U.S.C. FOUNDATION INVESTIGATION
REPORT.
U.S. 60-F-67 -- U.S. 6-60.

Re: M.C.S. Overpass & Hwy. 13,
Akersburg, Bridge Office
No. 1 of 2, District #1.

REVIEW OF PRELIMINARY PLAN

N.Y.C.R. Overhead, Hwy. #18,
Review of Preliminary Plan D-5457-P1
W.P. 6-60 -- W.J. 60-F-69

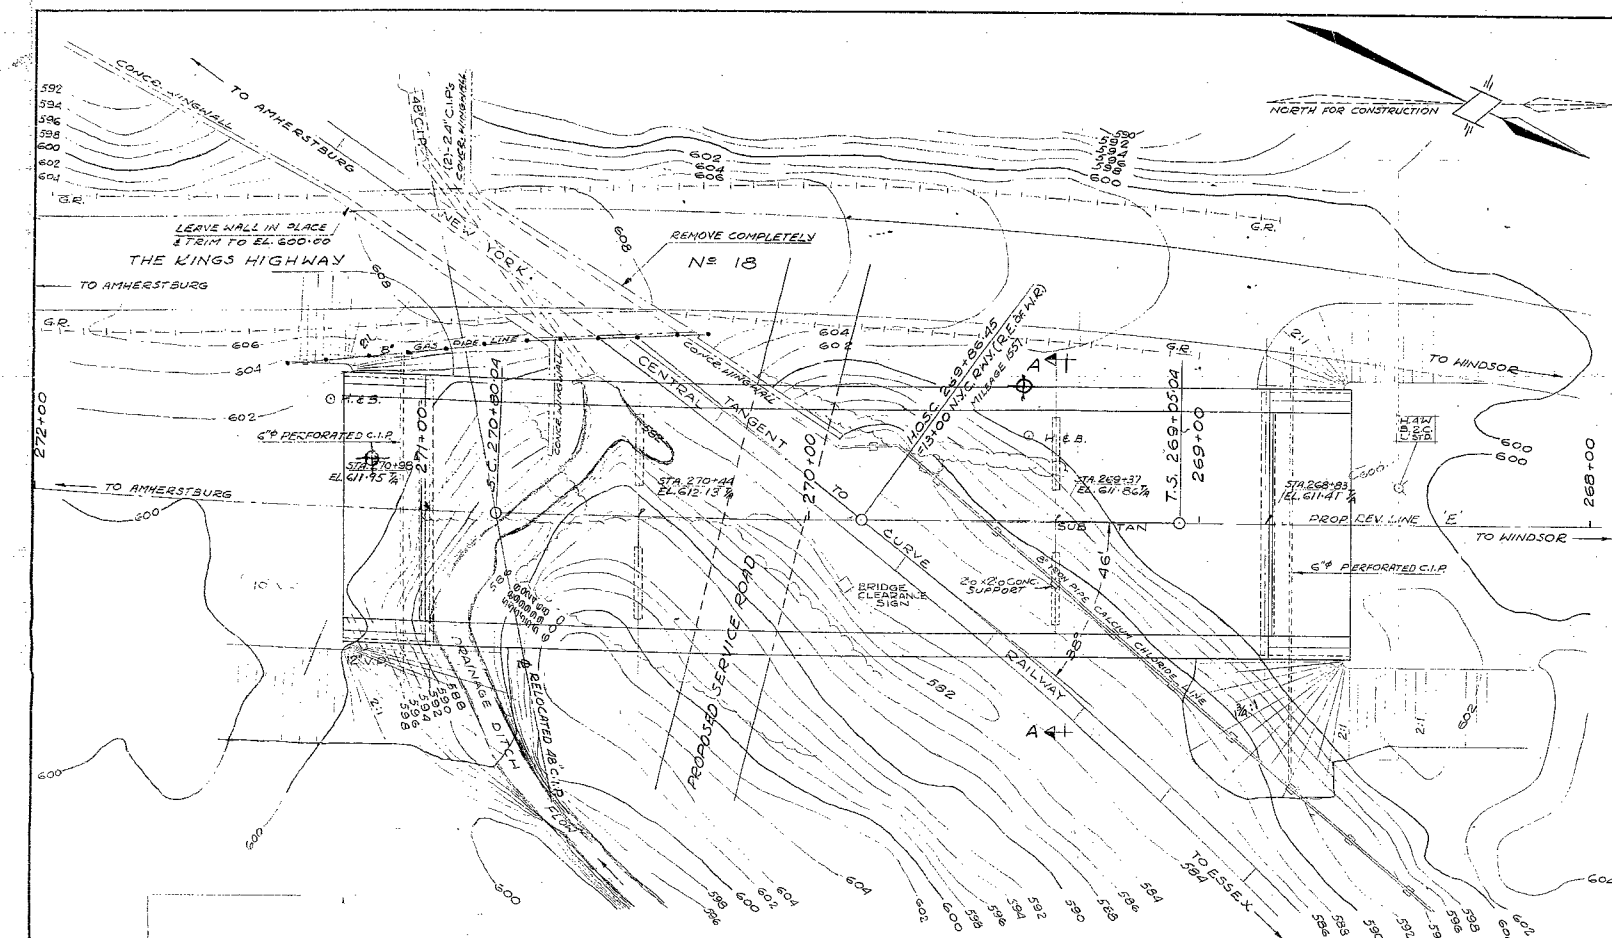
The drawing shows the north abutment to be
supported within the approach fill on 10 BP at 42 H-piles,
12 feet in length. We feel that this is not a satisfactory
arrangement because of the fact that the clay subsoil in
that area becomes increasingly soft with depth, and there
is every possibility that some of the piles would penetrate
a soft zone. We are of the opinion that a spread footing
type foundation should be used to support the abutment in
question. This may be placed either in original ground or
on well-compacted granular fill material.

APPROVED	BRIDGE ENGINEER	SITE No. 6-121	W.P. No. 6-60
DESIGN L.H.F.	CHECK A.K.	CONTRACT No.	
DRAWING G.P.	CHECK A.K.	DRAWING No.	D-5457-P
DATE FEB. 1964	LOADING 1420.316

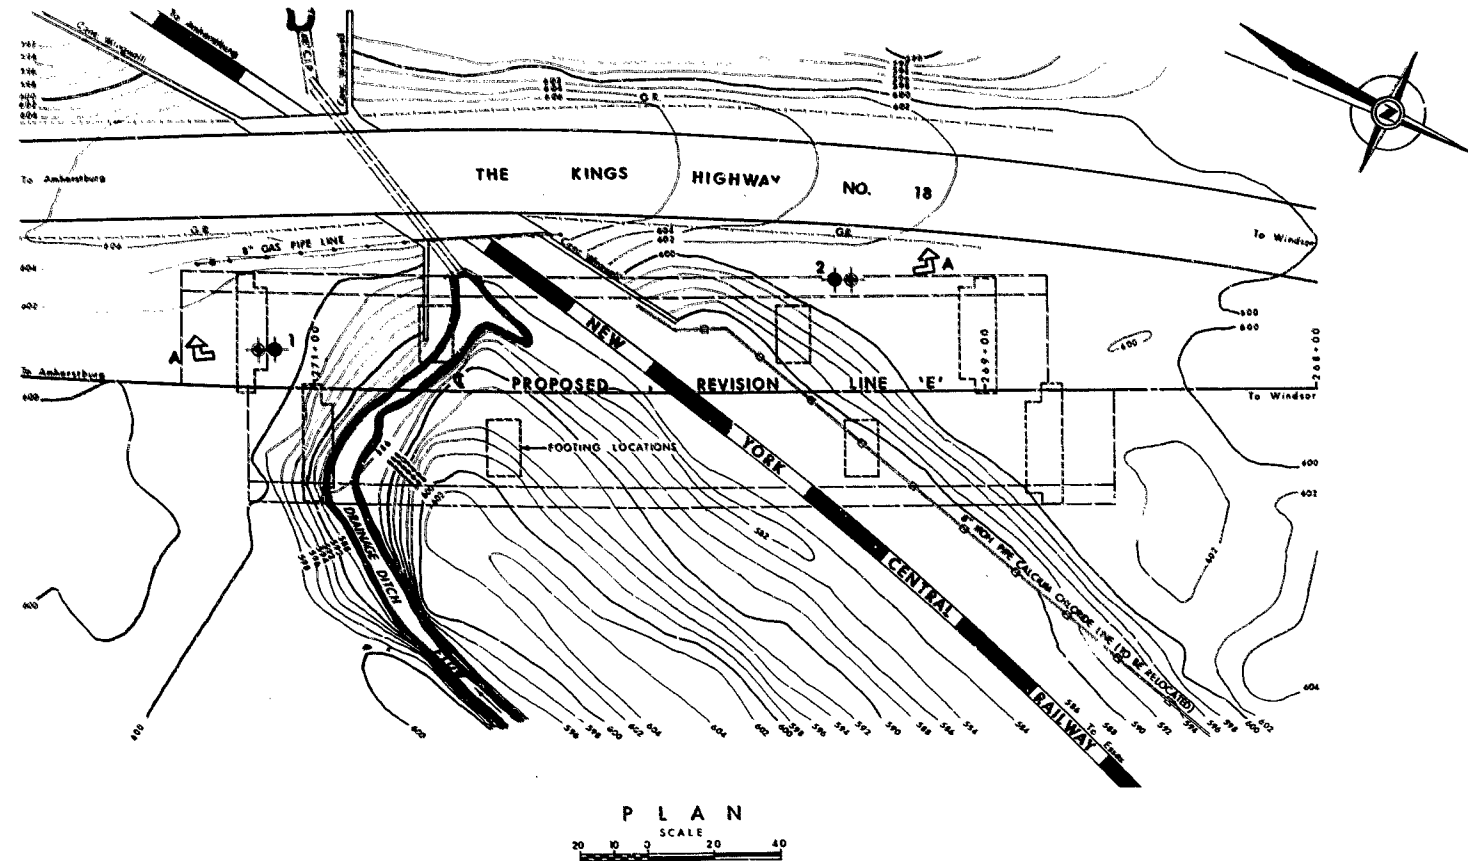
The soil report allows two tons per square foot on spread footings; however, due to our long centre span we would like to increase this to three tons by going deeper. Can this be done?

Also would you recommend a pile type, allowable load and approximate length at the abutments? We have indicated 12 BP 53 piles however timber or tube piles may be more suitable.
